## **Goring on Thames Neighbourhood Plan: Planning Application Assessment**

GORING-ON-THAMES PARISH COUNCIL	Planning Committee Response 26.08.20
Planning reference number	P20/S24488/FUL
Summary of application	GNP6 Full Planning Application

Figure 40 Diagram of detailed sightlines for SSR 5

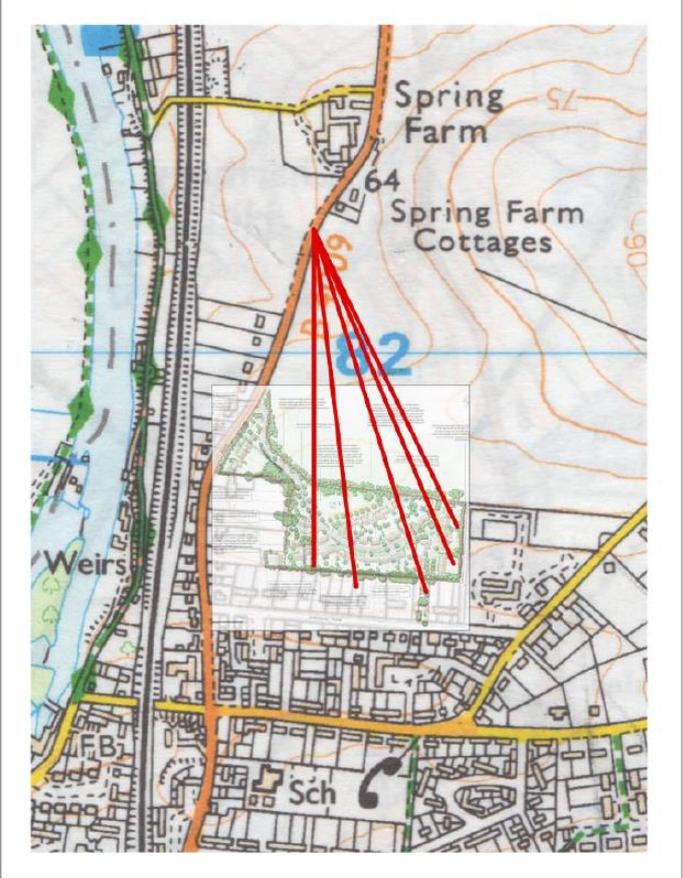
<p>5. Rooftops and screening for houses on the site should not be visible above the ridge line in views from Wallingford Road, particularly from between Spring Farm Barns/Cottages and 91 Wallingford Road but also from the road to the north of the Spring Farm hamlet.</p> <p>Detailed cross-sections should be taken along a series of sightlines including but not limited to those shown on the plan below to ensure that this condition is met.</p> <p>See end of document</p>	<p style="text-align: center; color: red; font-weight: bold;">N</p>	<p>Only one cross section showing the crest of the hill has been provided in the Design and Access Statement 3.8. The profile shows how close the roof lines of the highest buildings are to the crest and how vulnerable this sight line is to any future changes eg TV aerials, satellite dishes, fences, trees etc</p> <p>The SSR requires a series of cross-sections from different positions to be provided (see left). This requirement was reiterated by SODC in the Pre-app report.</p>
